**Request for Revision of Monitoring Plan**  
"Jincheng Sihe Coal Mine CMM Generation Project" (1896)

## Request for Revision of the Monitoring Plan, acc. to EB 49, Annex 28

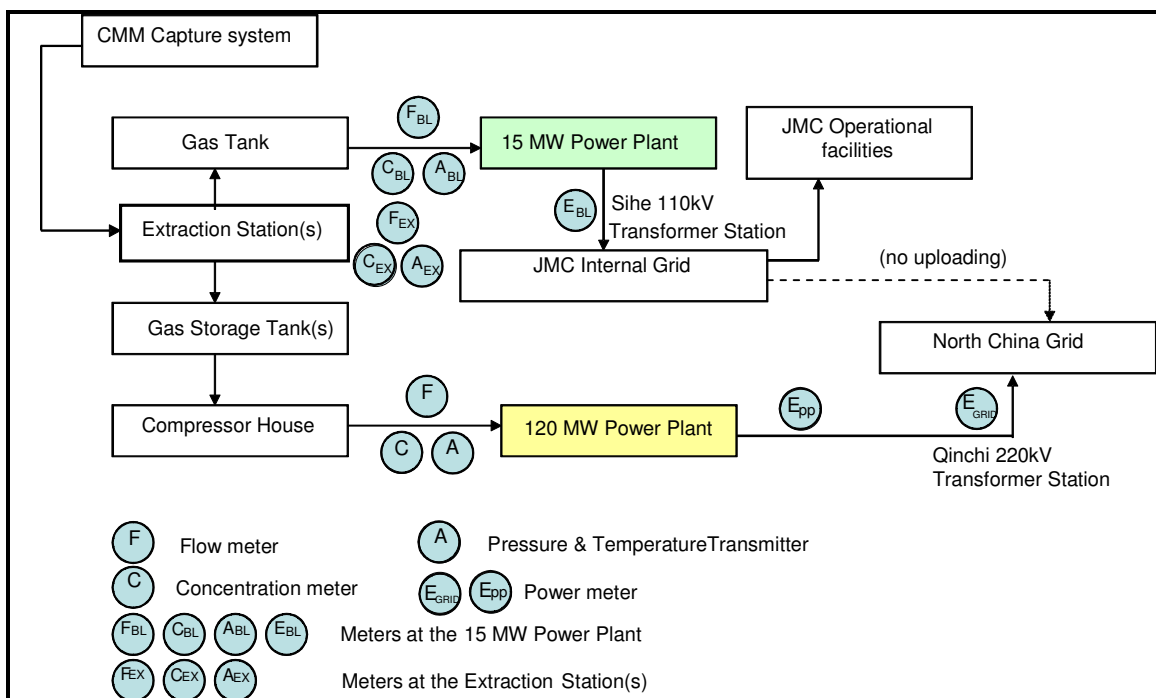
In the revised monitoring plan, section B.7.2 has revised some details regarding the location of installed meters and references in Figure 3, to provide a clear and complete picture of the monitoring system of the project activity. The new Figure 3 is as follows:

Corresponding details have been also included in point 3 “Monitoring of power generation and CMM consumption of the existing experimental 15MW power plant” and 6 “Monitoring of electricity to be supplied to and imported from the grid for the project activity” of section B.7.2.

B. Assessment of requested change	
Compared to the Figure 3 in the registered MP, the revised Figure 3 has mainly the following changes:	
<ul style="list-style-type: none"> <li>• changed the wording for “Extraction Pump” to “Extraction Station(s)” to be more precise on description of the extraction stations;</li> <li>• changed legend “A” from “Composition analyzer” to “Pressure &amp; Temperature Transmitter”, which is in accordance with the revision for “MM<sub>ELEC</sub>” “MM<sub>total,y</sub>” and “MM<sub>release,y</sub>” ;</li> <li>• included F<sub>EX</sub>, C<sub>EX</sub> and A<sub>EX</sub> at the “Extraction Station(s)” to describe meters locations for “MM<sub>total,y</sub>” and “MM<sub>release,y</sub>” ;</li> <li>• changed the legend F<sub>BL</sub>, C<sub>BL</sub>, A<sub>BL</sub> and E<sub>BL</sub> from “Meters for the existing facilities” to “Meters at the 15 MW Power Plant”</li> <li>• divided legend “E” to “E<sub>GRID</sub>” and “E<sub>PP</sub>”, to better distinguish the invoicing meters at the Qinchi 220KV Transformer station and the crosschecking meters at project site;</li> <li>• deleted “E<sub>BL,GRID</sub>”, since there is no uploading of electricity to the North China Grid from the existing 15MW power station.</li> </ul>
